ADDENDUM

SUBJECT: **ADDENDUM TO ITEM W12c, CDP NO. 5-21-0244 (STREAMS) FOR THE COMMISSION MEETING OF WEDNESDAY, OCTOBER 13, 2021.**

Project Title: **STREAMS RESIDENCE**
 7012 VISTA DEL MAR LANE, PLAYA DEL REY CA 90293

NORTH ELEVATION

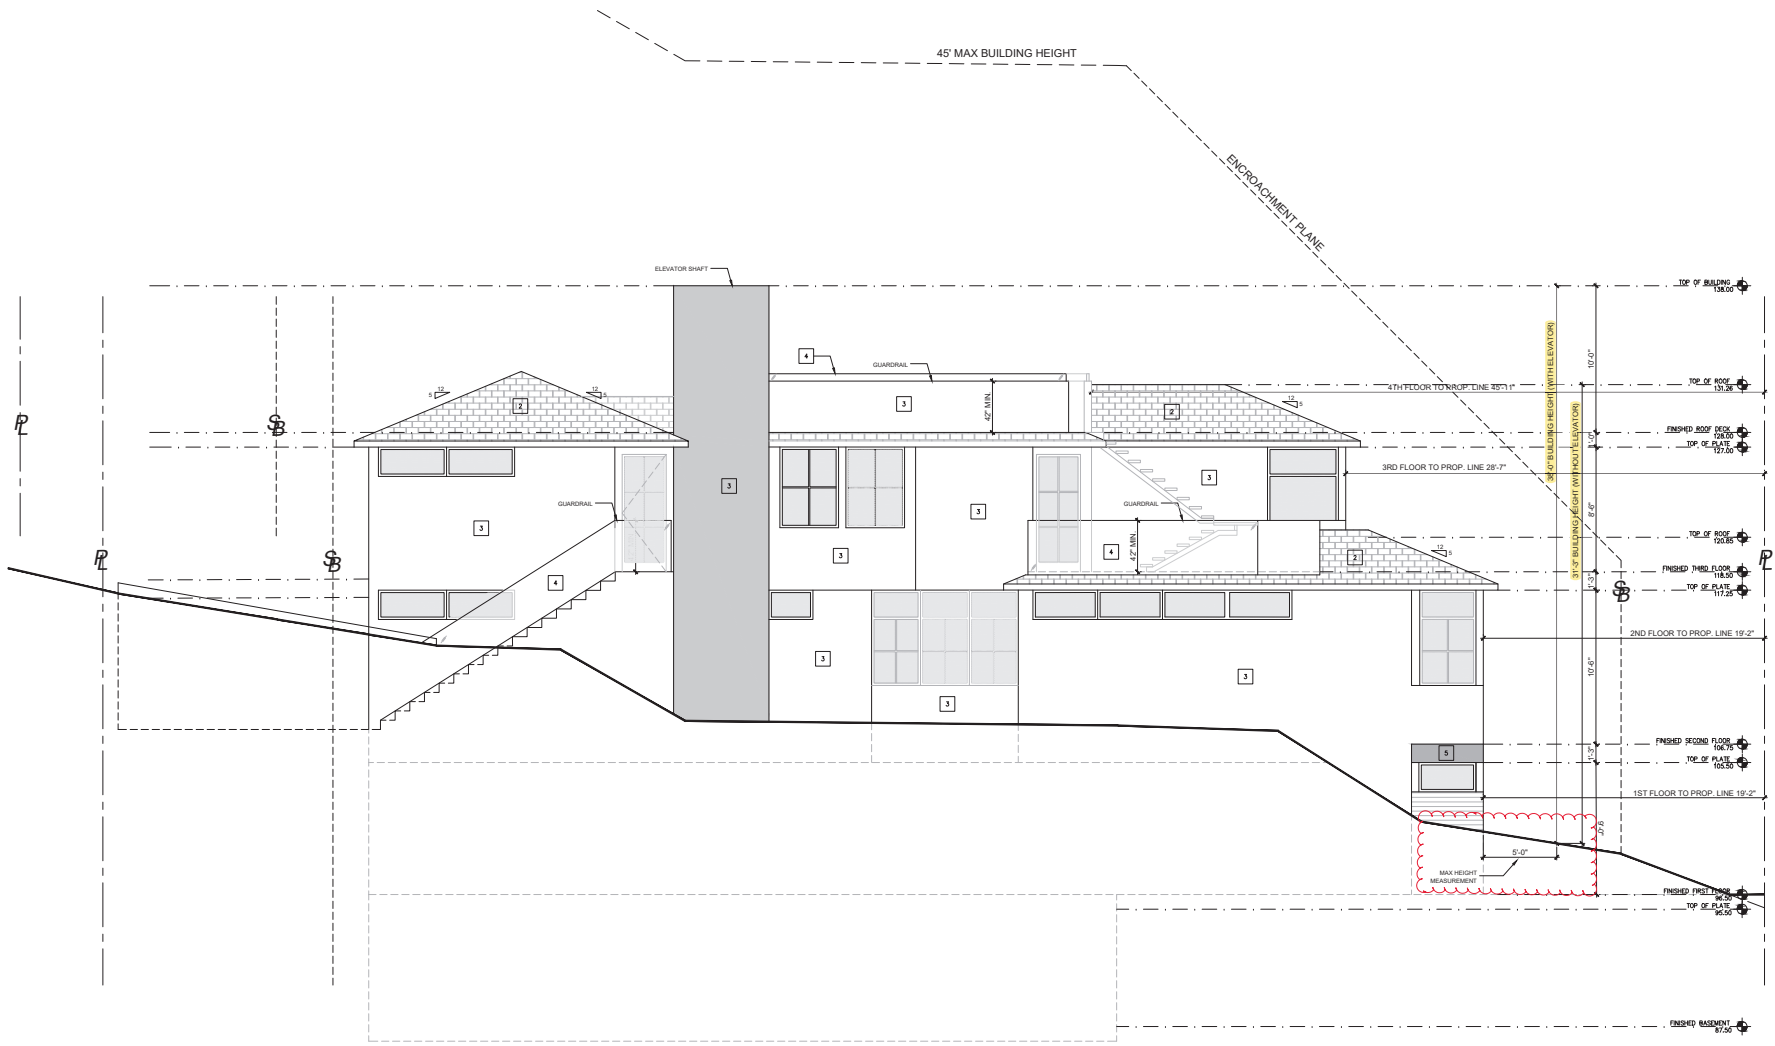
4. Exhibit 2, page 7 of 11, shall be replaced with the following correct North Elevation Plan which portrays the correct building height without the elevator:
